SG/GK  
14022  
6 February 2017

**S96(1A) - MODIFICATION APPLICATION - SSD 6673  
BLOCK 11, CENTRAL PARK**

**Figure 1** – Amalgamations of units W305 and W306 on Level 3 West  
Source: FJMT

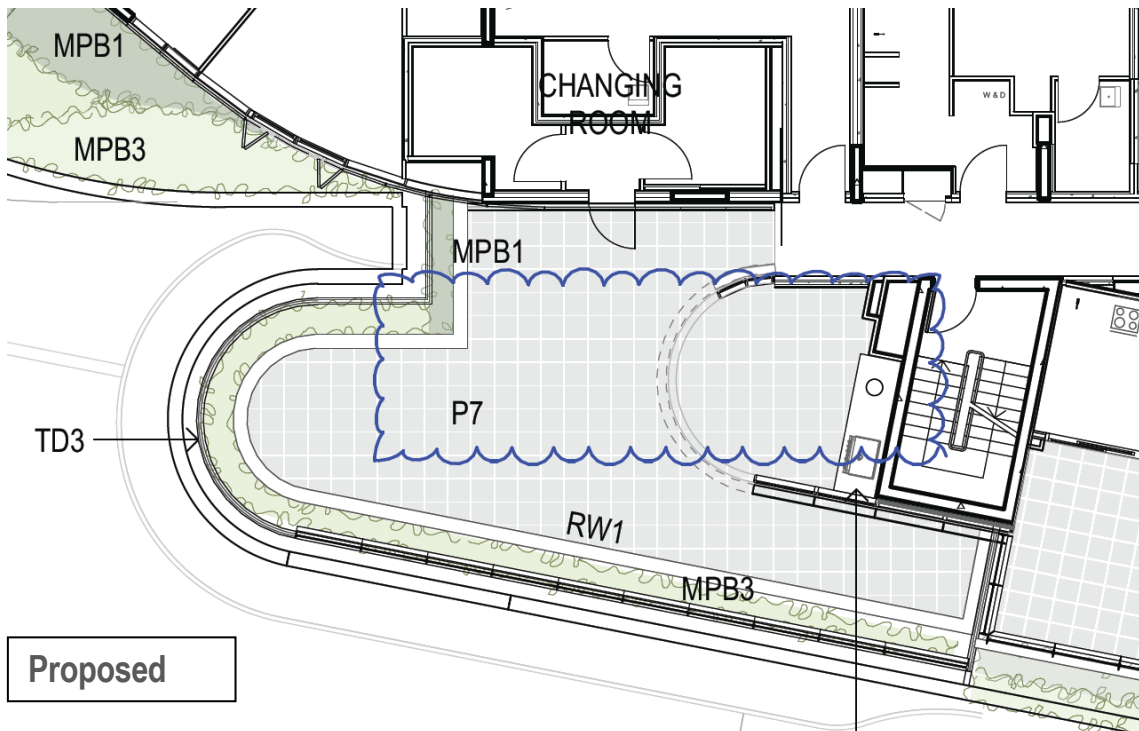
A modification is proposed to amalgamate approved units W305 and W306 located on level 3. These units are located on the northern elevation of the building on the western side, with views towards Chippendale Green. The modification will create one single four bedroom unit in place of 2 x two bedroom units as shown below in **Figure 1**.

The modification results in the total number of apartments within the development from 294 to 293.

**Figure 2** – Modification to Level 9 terrace – removal of jacuzzi  
Source: FJMT

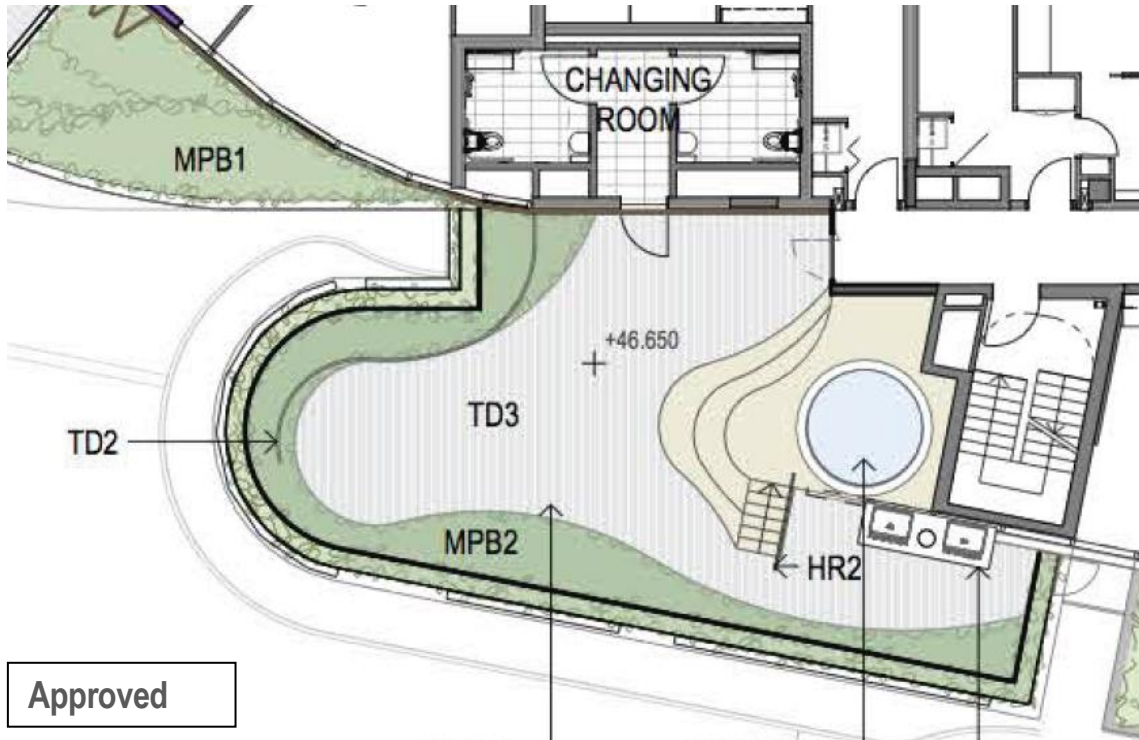
As part of the design development of the communal areas and landscaping, it is proposed to remove the jacuzzi that was approved on Level 9. This area will be retained as communal space for use by the residents. The BBQ and sink have also been relocated to a more appropriate location. The approved and revised design are shown below in **Figure 2**.

**Figure 3** – Southern elevation showing location of childcare centre balustrade glazing  
Source: FJMT

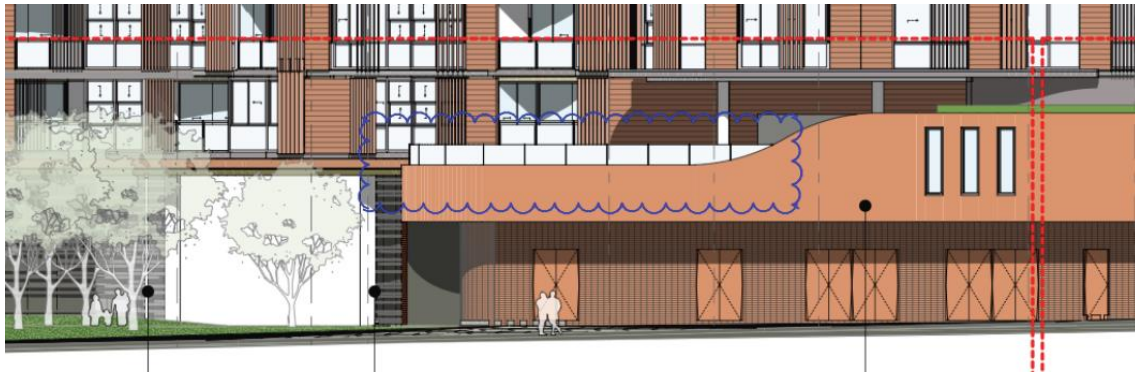
In response to wind conditions imposed on the approval as part of MOD 1, detailed wind investigations have been undertaken on the site. These included the outdoor areas of the Childcare centre located on Level 1, as shown in **Figure 3**.

In order to provide suitable wind environment in this location, and to comply with the Sydney DCP 2014 it is proposed to provide a 1.8m high glazed balustrade along the southern elevation of the childcare centre outdoor play space. The balustrade will remain as clear glazing and the Childcare DA will detail all landscaping and screen planting.
